TO: City of Gainesville
Development Review Board

FROM: Planning and Development Services Department

DATE: November 22, 2016

SUBJECT: Petition DB-16-124 SUB. JBrown Pro Group Inc. (Jay Brown), agent for Linda Hess, owner. Design plat review for a cluster subdivision. Zoned: RSF-1 (3.5 units/acre single-family residential district.) Located at 5041 NW 23rd Avenue.

**Map 5.
Wiltshire Cluster Subdivision Typical Roadway Cross Section.**

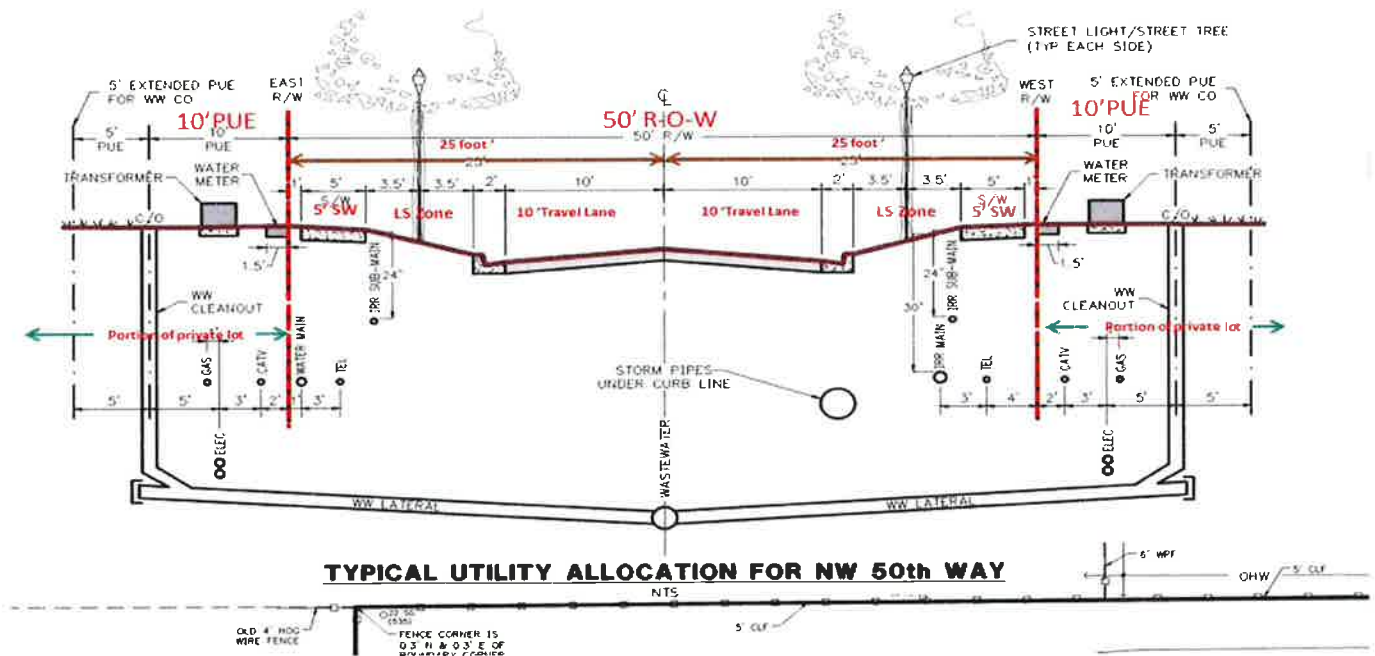
Streets are required to have a minimum width to provide for adequate traffic volume, street tree, public convenience, safety, and to adequately serve the uses intended. The require width varies depending on the roadway type but typically, local streets are required to have a right-of-way width of 50-feet, 24 feet of paved driving lane, plus additional easements to accommodate utilities. The proposed subdivision has provided a design cross-section, Map 4, indicating compliance with the requirements. The applicant is proposing a travel lane width of 10 feet which has been approved by Public Works.

The roadway systems within the subdivision are intended to be constructed as private streets. Notwithstanding, all roadway construction shall be in accordance with the standards as specified in the Public Works Design Manual. Roadway widths may be modified by the staff upon a determination that the required standards cannot be met and the requests are approved by the DRB and City Commission

Condition 4.

Except as modified under this petition, all roadways shall be constructed to the standards as specified in the Public Works Design Manual.
